DOCUMENT CHANGE REQUEST

DCR number 371

Title: CMOS 8-Stage Shift and Store Bus Register with Synchronous Serial Outputs and 3-State Parallel

Number: 9306/026

1.10 TRUTH TABLE AND TIMING DIAGRAM
page 14

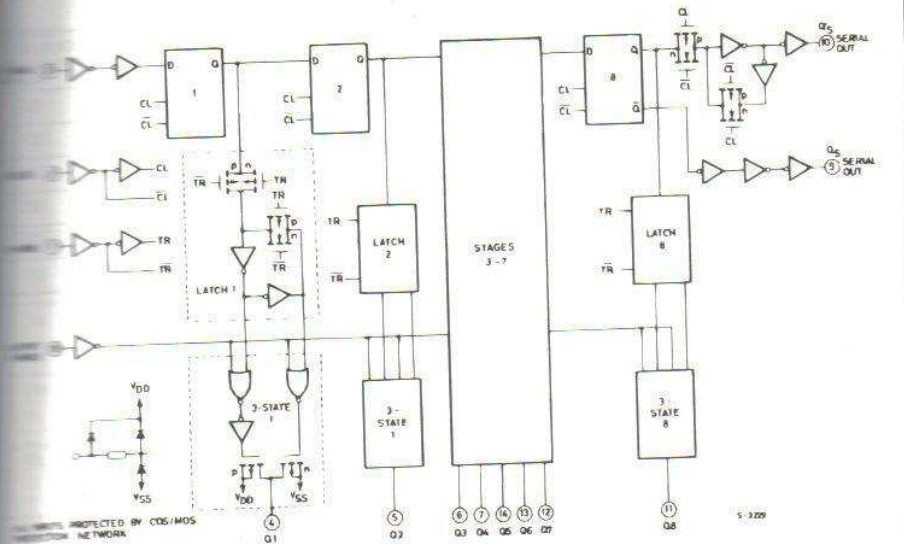
timing diagram is wrong.

during migration from old ESA/SCC form to ESCC form, the diagram was copied and an error was introduced: the second negative pulse of STR shall start at the next falling front of CLK (in the same time as OE).
Good diagram is proposed in attached file
